Prairie Island Nuclear Generating Plant
1717 Wakonade Drive East
Welch, MN 55089

Prairie Island Independent Spent Fuel Storage Installation
Docket No. 72-10
Materials License No. SNM-2506

Supplement to License Renewal Application – Response to Second Request for
Additional Information (TAC No. L24592)

SUPPLEMENT TO LICENSE RENEWAL APPLICATION
RESPONSE TO REQUEST FOR ADDITIONAL INFORMATION

Figure A2.10-1
Two Meter Gamma Dose Rates

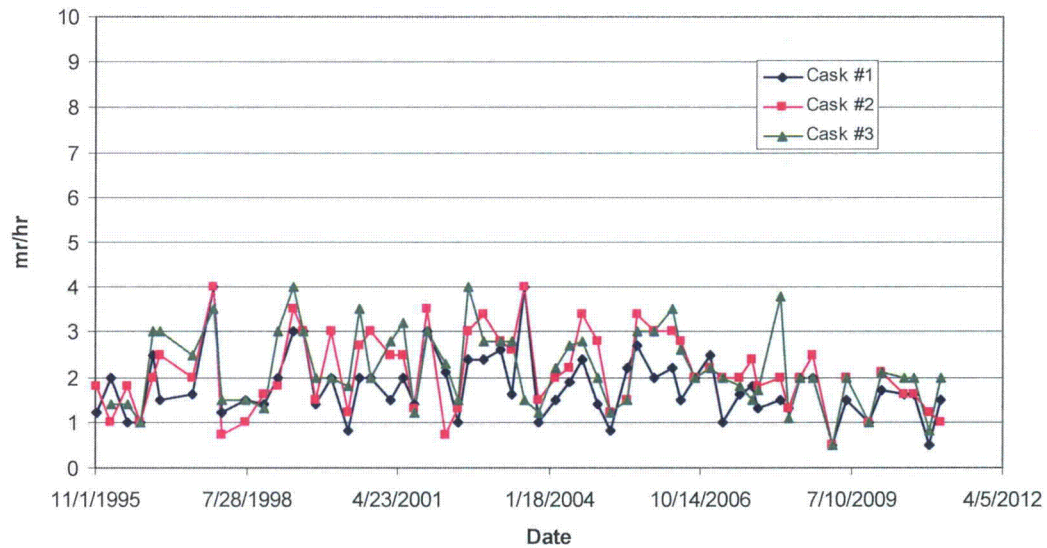
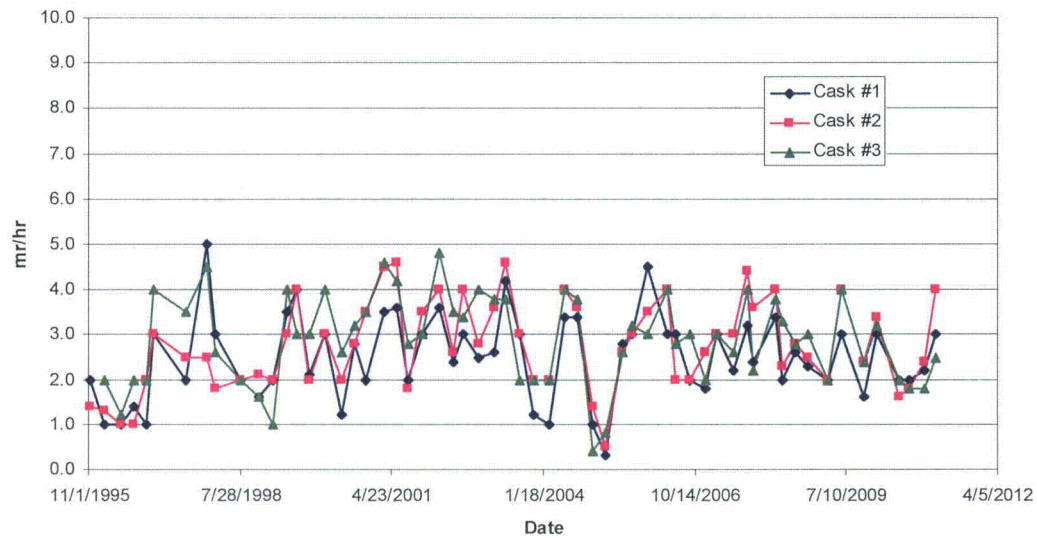
The staff believes that due to either inconsistencies in the measurement technique, equipment, locations, variations in background, or a combination of all of these factors, the data (LRA Figure A.2.10 -1.2, and RAI A-1 response) presented is insufficient to detect degradation of the

Trending neutron dose rate readings from the same location on each cask is consistent with the aging management principle of sampling representative locations and casks rather than 100% of surfaces on all casks, as further discussed in NUREG-1927, AMP Element 4 and Appendix E. While no attempt is made to ensure that the fuel loadings within a cask are truly symmetrical, it is reasonable to assume that the actual loads result in a fairly uniform radial source term. SAR Figure A7.2-2 shows the axial gamma and neutron power profiles, i.e., the axial source term, used in the safety analysis. This figure shows that the highest axial source terms are approximately one meter from the bottom of the cask. Since the most likely aging effect of the shielding material is due to radiation damage, it is reasonable to expect that the most likely location for degradation to occur is approximately one meter from the ground, and that any such degradation would be uniform radially. Therefore, trending neutron radiation readings from every cask, at an elevation of one meter, and at a single radial location two meters from the outer shell provides an adequate sample size to ensure timely detection of aging effects that could lead to a loss of intended function.

NSPM performs periodic radiation surveys of the in-service casks. Trending of these surveys results shows no evidence that the shielding is degrading. Figure A2.10-1 provides the gamma dose rates at two meters from the three casks that have been in-service the longest. Figure A2.10-2 provides the neutron dose rates at two meters from the three casks that have been in-service the longest.
